FORM APPROVED  
OMB NO. 1004-0135  
Expires: July 31, 2010**SUNDRY NOTICES AND REPORTS ON WELLS**  
*Do not use this form for proposals to drill or to re-enter an abandoned well. Use form 3160-3 (APD) for such proposals.***SUBMIT IN TRIPLICATE - Other instructions on reverse side.**

Well Name: WARREN UNIT 080W

**From:** Rogers, Rhonda S <Rhonda.S.Rogers@conocophillips.com>  
**Sent:** Monday, September 10, 2012 1:57 PM  
**To:** Jones, William V., EMNRD  
**Subject:** Warren Unit 80 injection well

# DOWNHOLE WELL PROFILE REPORT

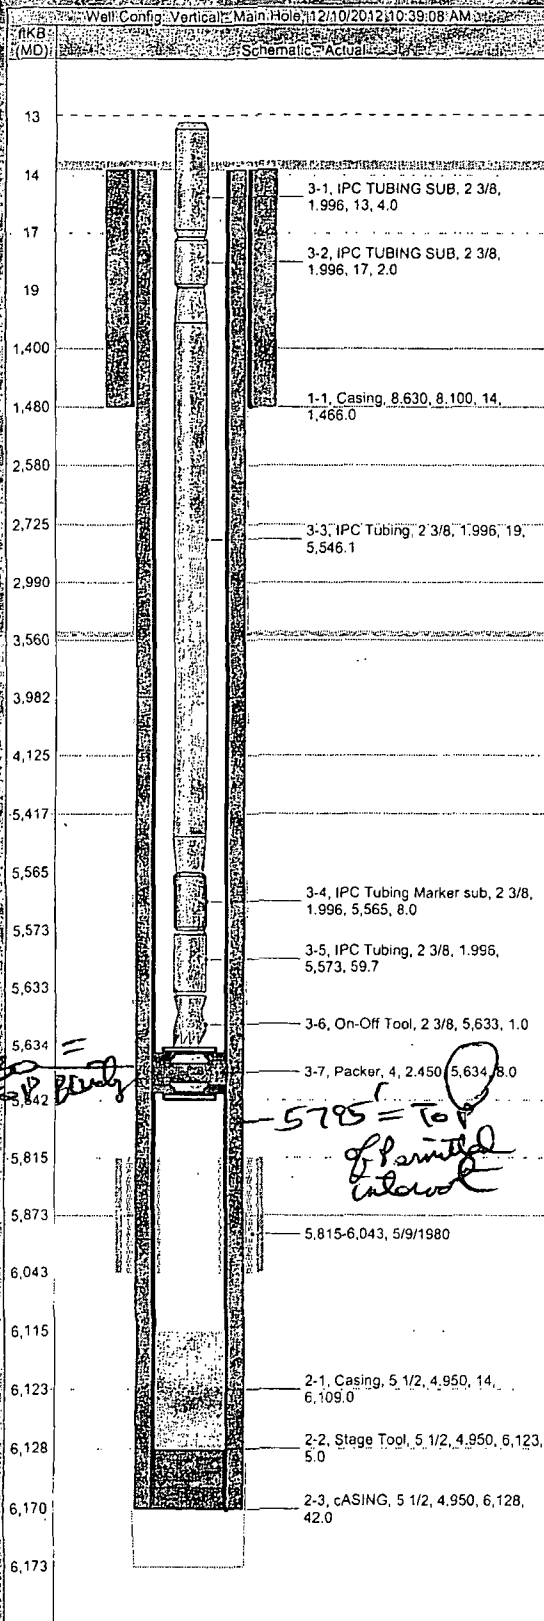
Rhonda,  
Send the permit number allowing injection into that well.  
Send the top of the unitized interval (for waterflooding) – ask you Landman for this.  
Send a wellbore diagram showing how it will appear after the packer is moved up.

It seems there is a disconnect with the top of the Blinebry being at 5630 feet and the top as defined in R-6906-B Paragraph (4). Would you run this by your geologist and Landman and ask about it?

Unless there is a huge difference in structure out there, the Blinebry top in this well #80 would be (legally defined) at similar depths and the new packer depth would be necessarily above the Blinebry and in the Paddock formation – which is fine if only 100 feet above.

Will I am sending the information you requested on the e-mail below. Attached is the proposed wellbore schematic. Please let me know if you need anymore information.

R-6906-B  
Top Blinebry = 5630' MD in this well  
1 PKR still in Blinebry

- The top in the order referred to the top of the **Blinebry Reservoir** (the top of the good Blinebry properties), COP has always had perforation intervals below the **Top Blinebry Reservoir**.
- The **Top Blinebry Reservoir** is 5865 ft MD in WU # 37. It is correlated to WU# 80 at 5795 ft MD. Structurally the top **Blinebry Reservoir** in WU # 80 is 70 higher than in WU # 37.
- The **Current COP Top Blinebry is the Top of Blinebry Formation**:
  - **The Top Blinebry Formation** in WU # 37 is 5710 ft MD which is correlated to the **Top Blinebry Formation** in WU # 80 at 5630 ft MD.

In conclusion the correlation in the order and current correlation referred to 2 different things. The 1<sup>st</sup> one refers to **Top Blinebry Reservoir** and the 2<sup>nd</sup> one refers to the **Top Blinebry Formation**. We are requesting that the packer be set inside the Blinebry Formation interval (within 10 feet of the top Blinebry Formation).
